Leg Is Part of Monopod

Forward support tube (mount)

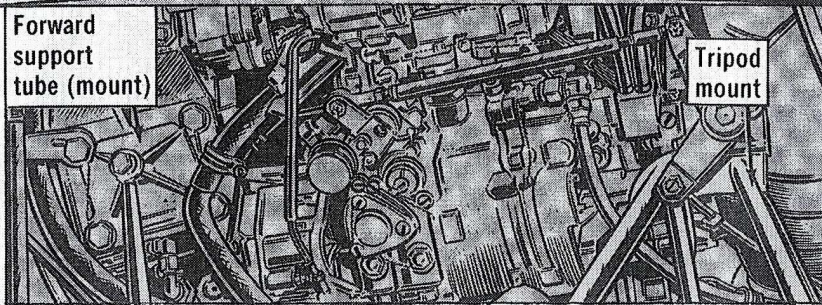
Dear Windy,
Fig 5-1 of TM 55-1520-210-20 identifies the forward support tube (item 12) as a "forward support leg." I say it's really part of the engine mount, and requires an engine alignment

check when it's replaced, regardless of the nomenclature in the figure. My maintenance people disagree. Who's right?

You are, Sarge. That tube is really a monopod, part of the engine mount. If any part of the engine mount (monopod, bipod or tripod) is changed, or the shim stack-up for any one of 'em is disturbed, you gotta make that drive shaft alignment check.
